SERVICE INFORMATION LETTER

DATE 04 august 2017 SIL-005/ZSJ/2017

SUBJECT: Control of elevator pushrod fork tip

CONCERNS: SZD 9 bis Bocian 1E , D , C

Control of elevator pushrod fork tip.

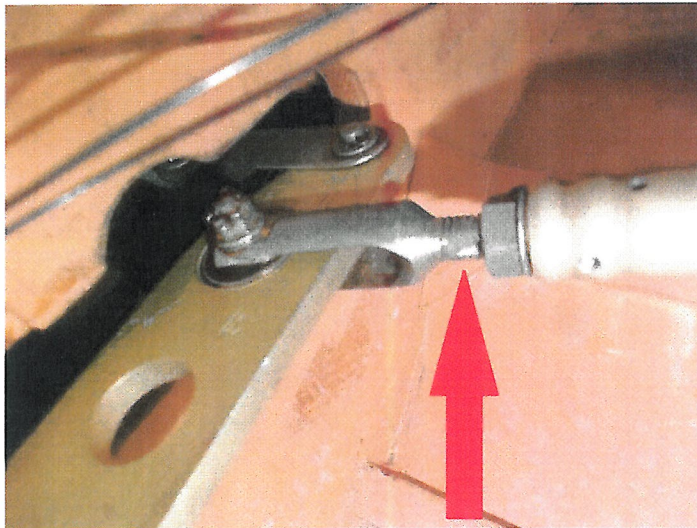
Open inspection hole located in left back part of fuselage.

By the mirror or inspection camera check condition adjustable pushrod tip per circuit.

Any damage or curvature of tip eliminate possible to fly until replace the tip.

Please check protection of elevator during airfield transport. Unsafely elevator can provide to uncontrolled impact pushrod in to intermediate lever. This can entail curve or crack of tip Any repair or straighten pushrod fork tip is forbidden.
